# UNITED STATES PATENT AND TRADEMARK OFFICE

| APPLICATION NO.  | FILING DATE | FIRST NAMED INVENTOR | ATTORNEY DOCKET NO. | CONFIRMATION NO. |
|--|-------------|----------------------|---------------------|------------------|
| 10/523,005   | 08/09/2005  | Yoshinori Fujii      | AI 373NP            | 4657             |

| <b>Office Action Summary</b> | Application No. | Applicant(s)       |

Figure 4

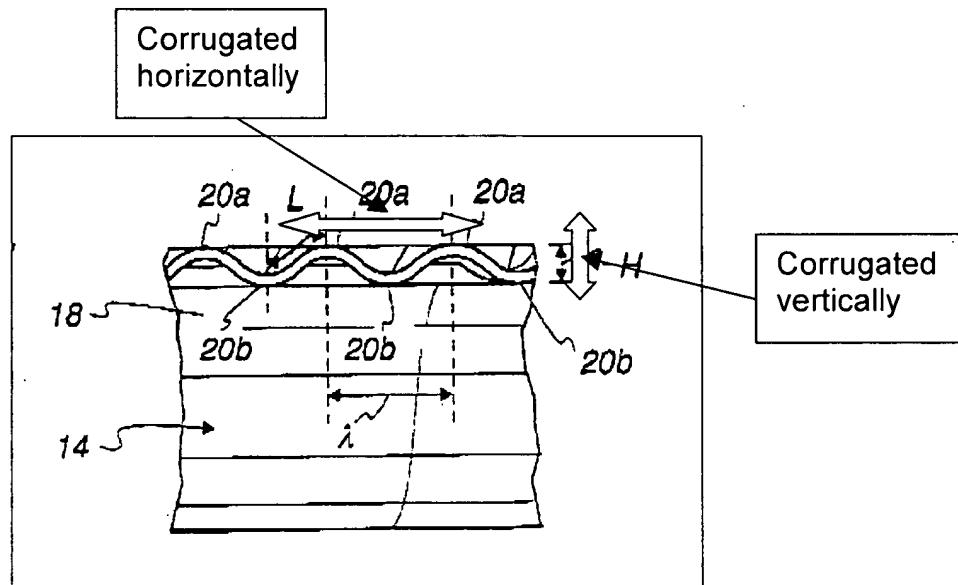
2. Claim 1 rejected under 35 U.S.C. 102b as being anticipated by Gentry (US 2001/0003341 A1). With respect to claim 1, Gentry discloses a packaging container molded of a synthetic resin [0017] having a peripheral edge encompassing an opening of the container being corrugated in a horizontal direction (see Figure 1 below).

5. Applicant's arguments filed 5/18/06 have been fully considered but they are not persuasive. Gentry discloses both vertical and horizontal corrugations as shown above in Fig. 1. The distance between two peaks CLEARLY demonstrates a horizontal corrugation and the amplitude in the vertical direction of one peak CLEARLY demonstrates a vertical corrugation.
